RE: Proposed Action Memorandum / Modification of the Corrective Action Section of the  
Operating Permit for Rocky Flats Environmental Technology Site - IHSS 109, OU2

PROPOSED ACTION MEMORANDUM AND  
MODIFICATION OF THE  
CORRECTIVE ACTION SECTION OF THE OPERATING PERMIT  
FOR ROCKY FLATS ENVIRONMENTAL TECHNOLOGY SITE

Figure 1  
Thermal Desorption Process Flowsheet

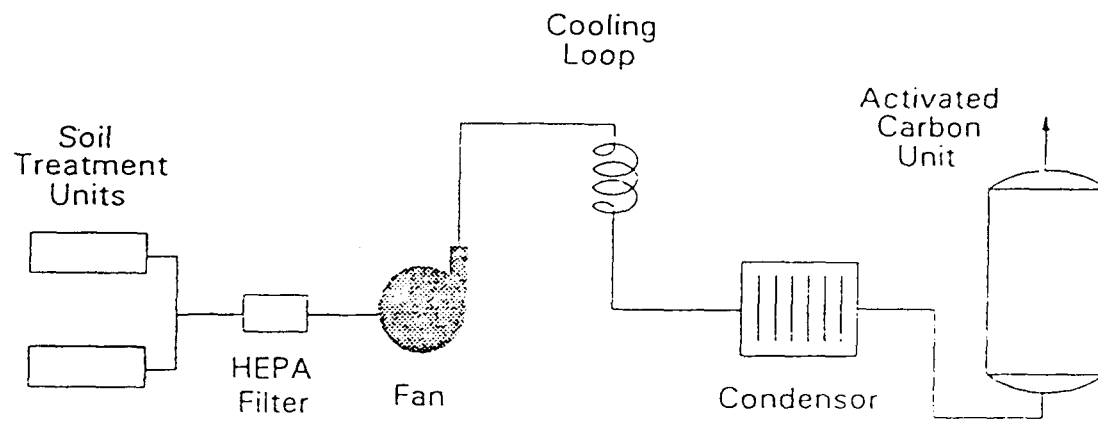
- Any monitoring equipment described should also be shown in a revised process flowsheet (Figure 1).
- Provide additional waste analyses giving the heating value of the material to be treated and verifying that lead and mercury have not been detected above background levels (6 CCR 1007-3, Part 265, Subpart P).
